Dean Moor Solar Farm

Environmental Statement: Appendix 7.8 – Arboricultural Impact Assessment

26 August 2025
Prepared by: Stantec UK Ltd
PINS Ref: EN010155
Document Ref: D2.17
Deadline: 2
Revision: 2

Table 1.1: Revisions to Appendices B and C of the AIA

Stantec

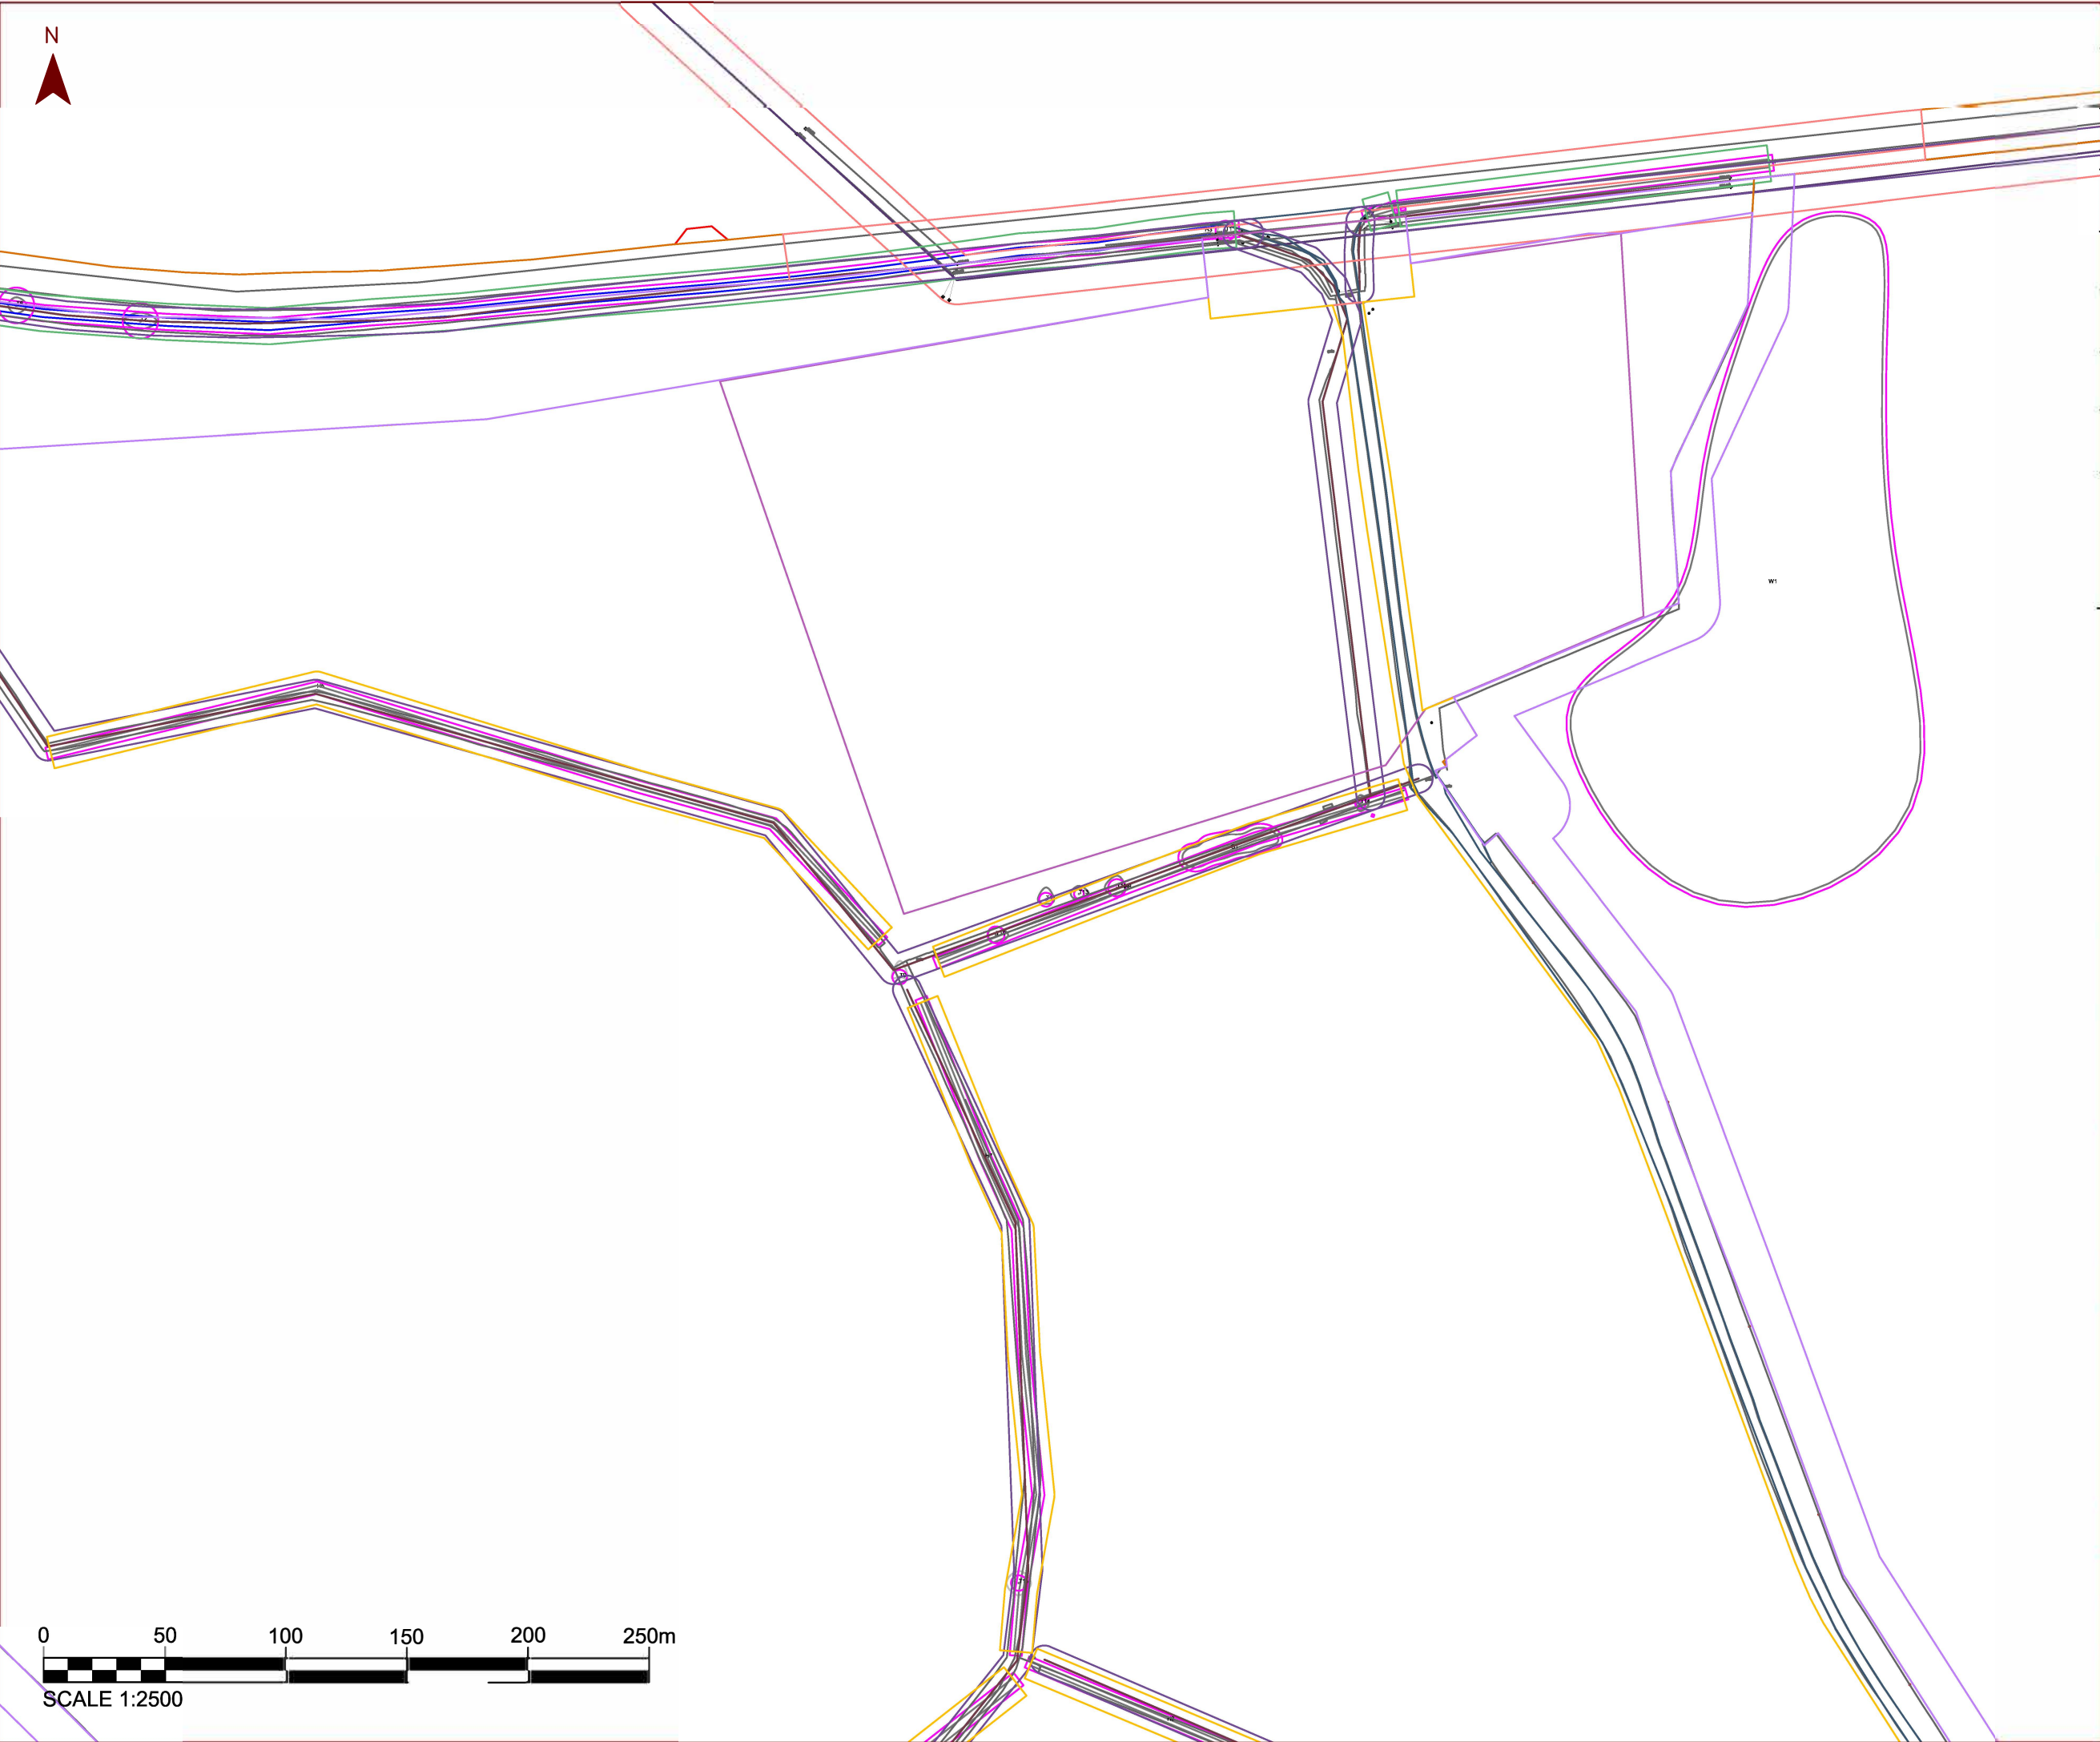
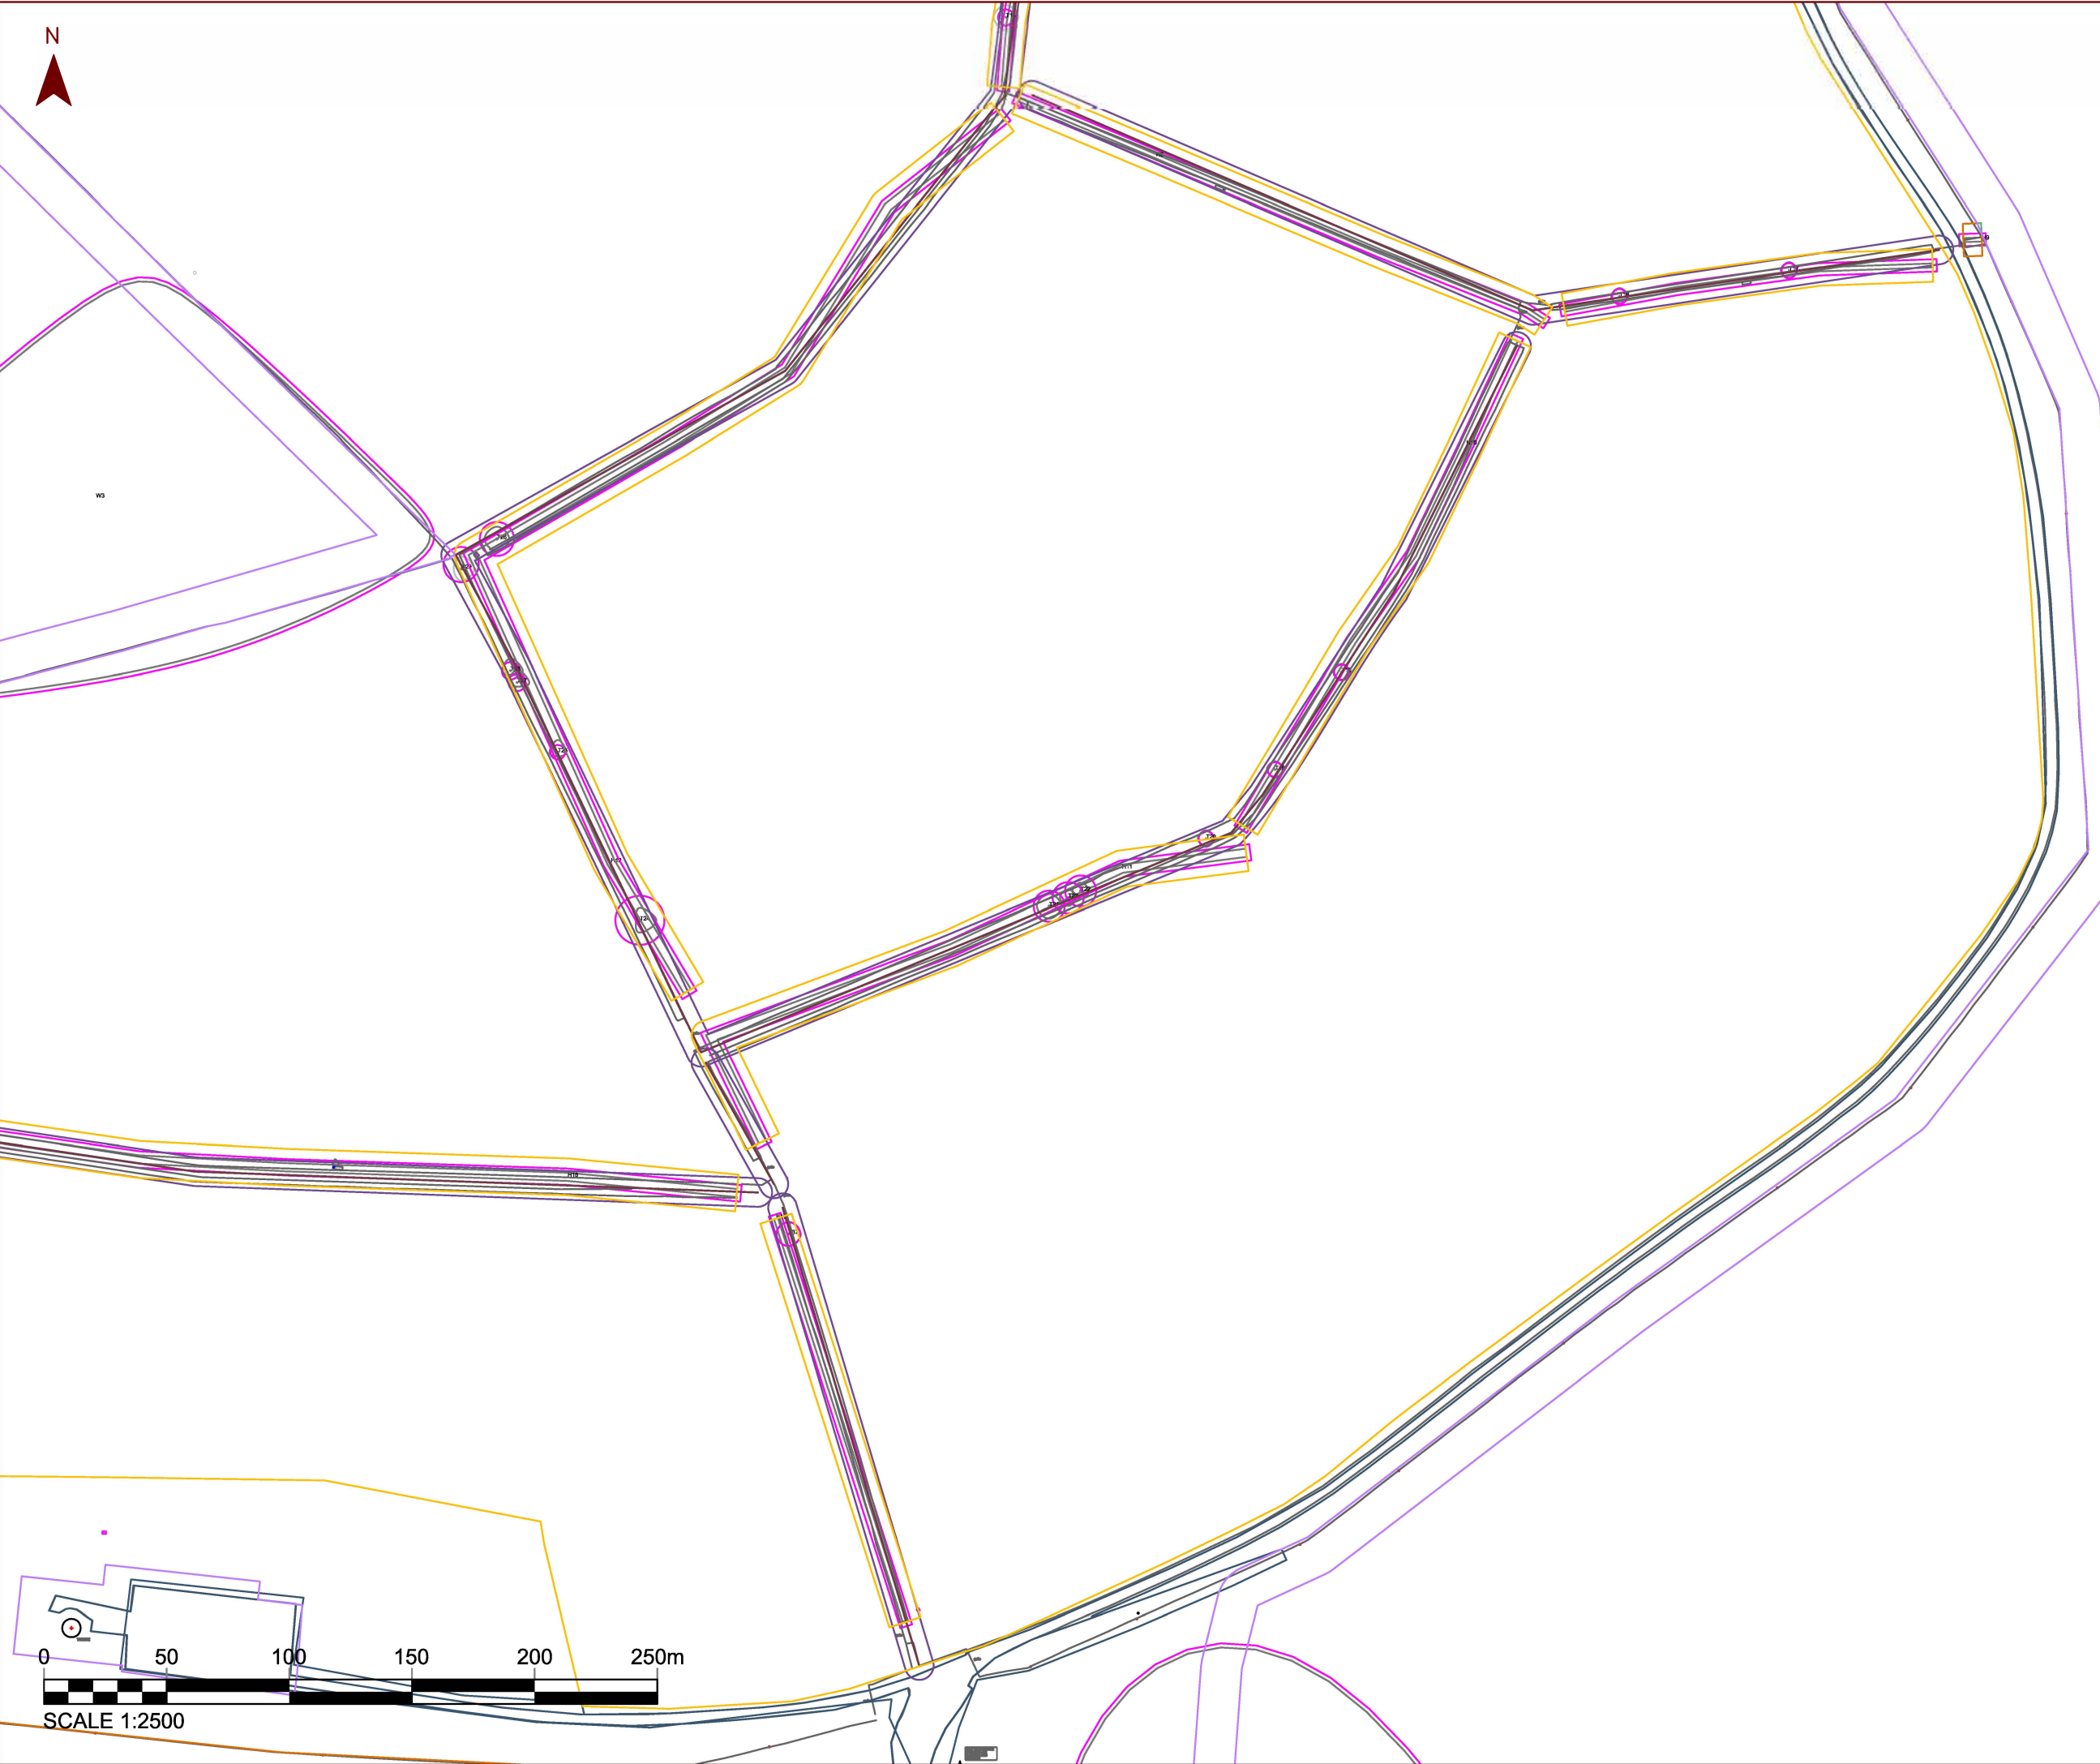
Revision	Reason
Change of the plan title in the TCP from 'Location Plan' to 'Tree Constraints Plan'	To make it clear that the plan is displaying the TCP. As the Location Plan is a different figure within the ES.
A renumbering of the sheets included in the TCP. Changing the order from 0-22 to 1-23.	To enable the first sheet within the TCP is numbered 1 rather than 0.
Change of the plan title in the TPP from 'Location Plan' to 'Tree Protection Plan'	To make it clear that the plan is displaying the TPP. As the Location Plan is a different figure within the ES.
A renumbering of the sheets included in the TPP. Changing the order from 0-22 to 1-23.	To enable the first sheet within the TPP is numbered 1 rather than 0.
